Hydrol. Earth Syst. Sci. Discuss., author comment AC1 https://doi.org/10.5194/hess-2021-47-AC1, 2021 © Author(s) 2021. This work is distributed under the Creative Commons Attribution 4.0 License.

Reply on RC1

Author comment on "Impact of detention dams on the probability distribution of floods" by Salvatore Manfreda et al., Hydrol. Earth Syst. Sci. Discuss., https://doi.org/10.5194/hess-2021-47-AC1, 2021

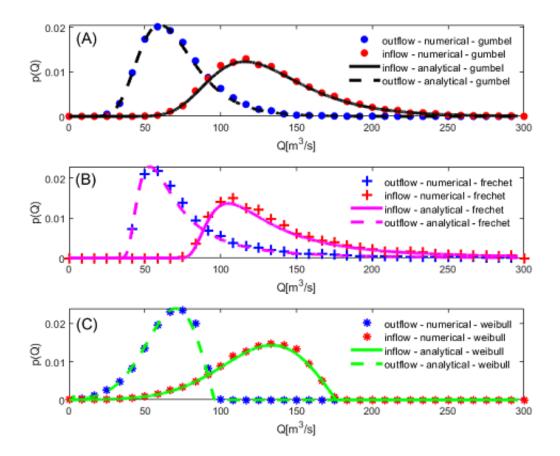
RC: Finally, I believe the readers would be very curious to see how the results would be modified if a heavy-tailed distribution was used instead of the Gumbel which has exponential tail. The exponential tails offer "no surprises" in the generation of random discharge values and thus the good results shown might be case specific and only for the Gumbel distribution. What would be the performance if really heavy tailed distributions were used, e.g., a GEV with shape parameter close to 0.5?

AC: In order to satisfy readers' curiosity, we provide in the following few examples where the peak outflow distributions are derived using flood peaks distributed according to the three types of GEV distributions (Gumbel, Fréchet and Weibull). Reliability of the derived distribution has been tested using a numerical simulation, which demonstrates the good agreement with the theoretical functions.
